**Modification/Change Order No. 5**

Fort Bend County Drainage District

EWP – Oyster Creek Channel Bank Stabilization Phase I

Modification/Change Order No.5  
Fort Bend County Drainage District  
EWP – Oyster Creek Phase I Channel Bank Stabilization  
Fort Bend County, Texas  
July 28, 2021  
Contract No: PO 195193

SITE PLAN - 413 AND SECTION VIEW  
 OYSTER CREEK - BANK STABILIZATION  
 FORT BEND DRAINAGE DISTRICT  
 IN  
 FORT BEND COUNTY, TEXAS

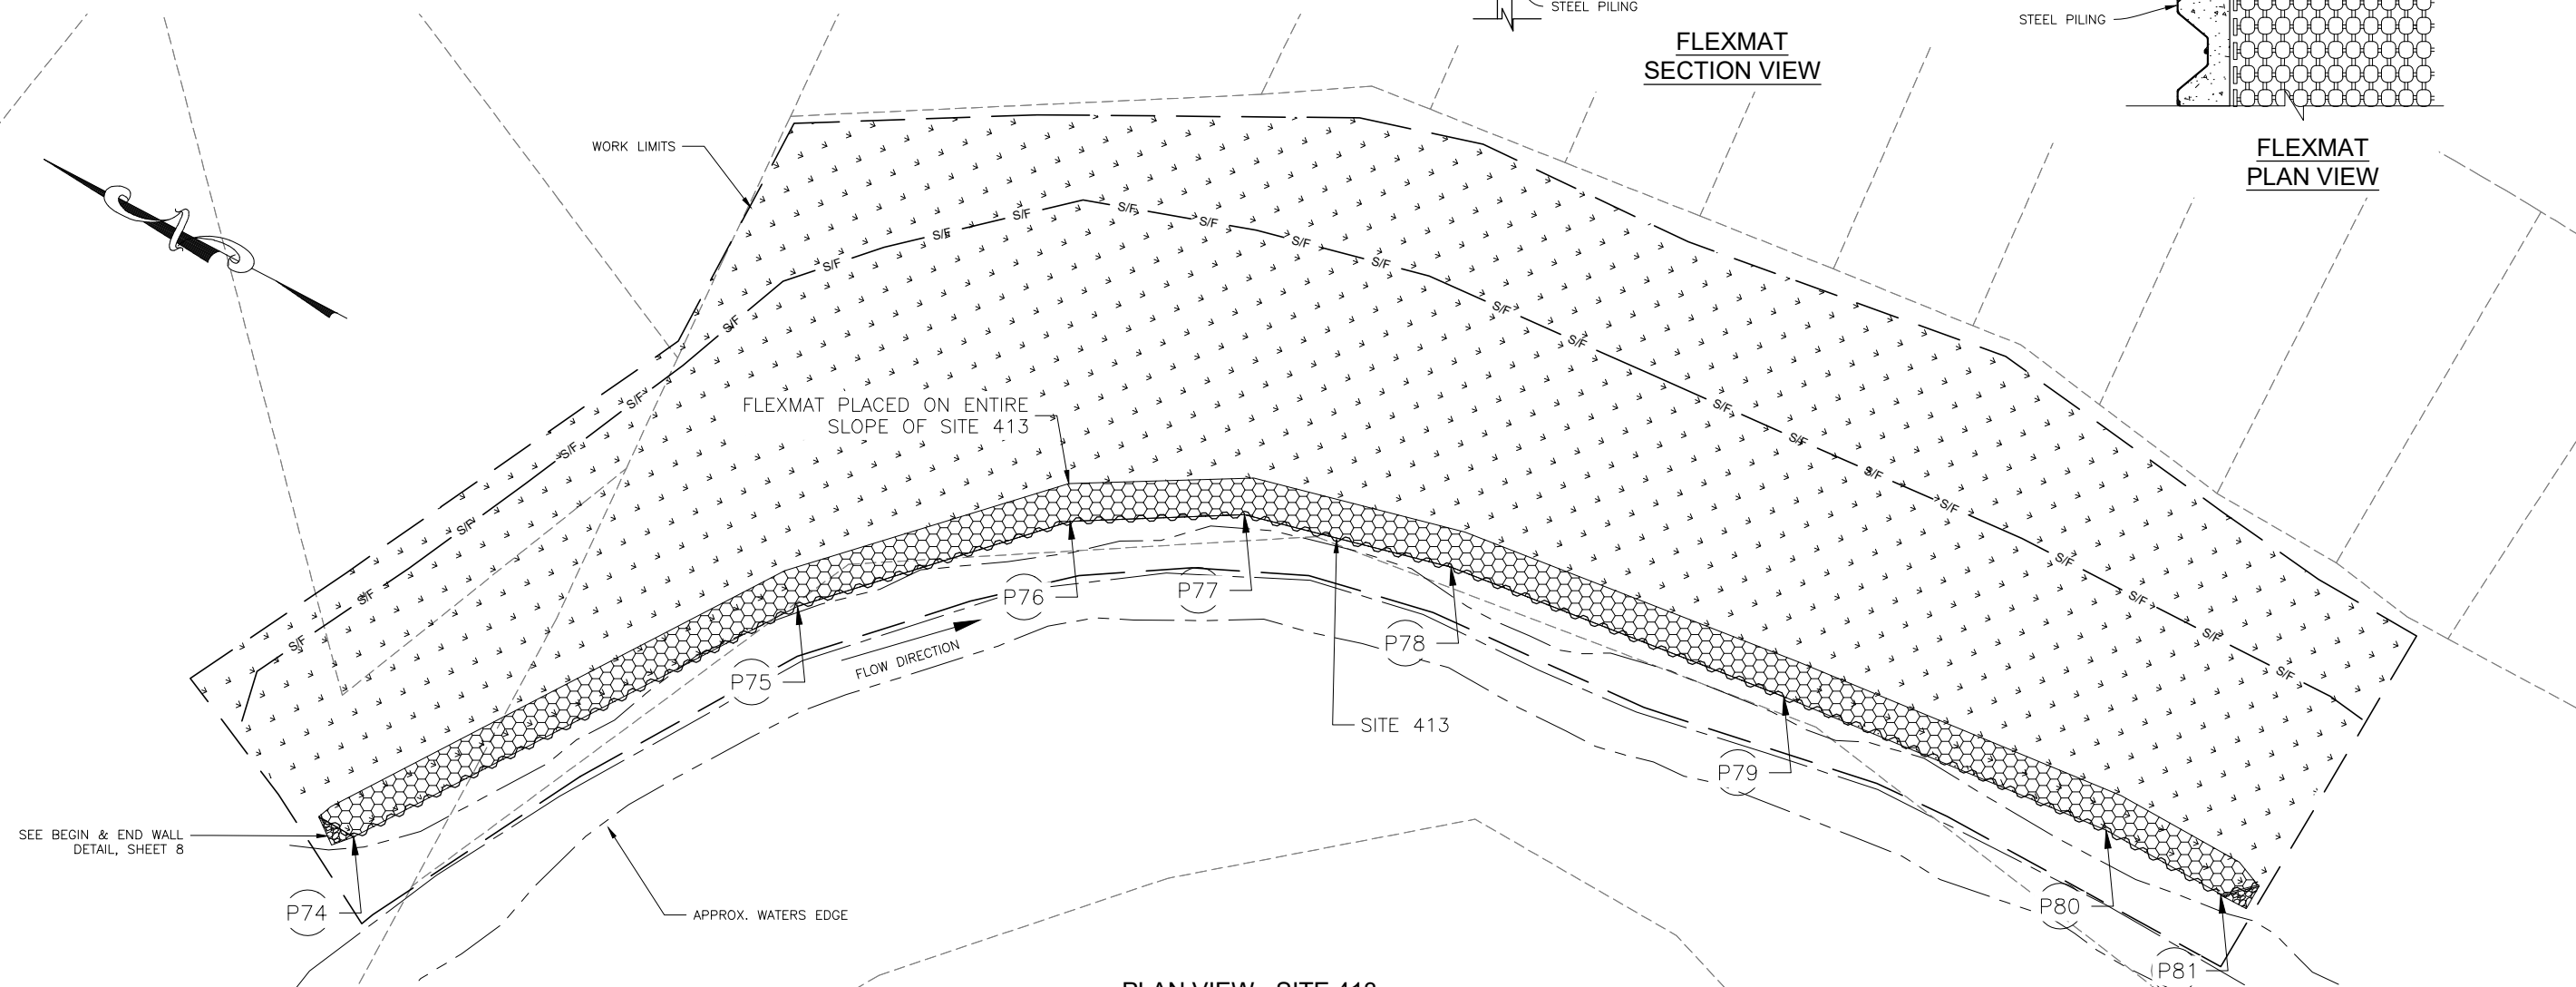
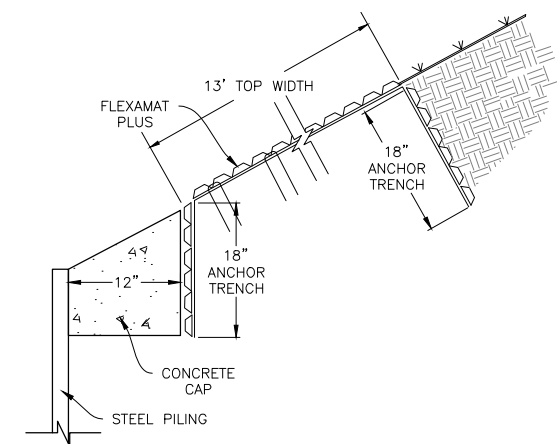
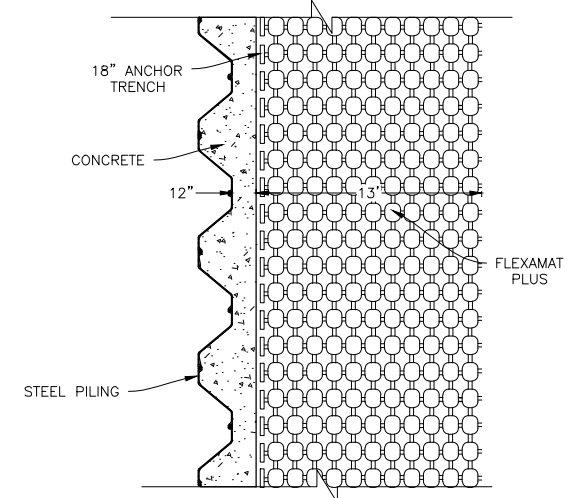
The Contractor shall furnish all labor equipment and material to install flex mat as shown on the attached drawing and specifications at Oyster Creek Phase I Site 413 revised. Measurement and Payment compensation shall be Method 3 in Construction Specification 495, lump Sum.

REVISIONS		
DATE	APPROVED	TITLE
4/29/21	BTS	WALLS REMOVED & RELOCATED
7/21/21	BTS	CONCRETE MAT ADDED TO SITE 413
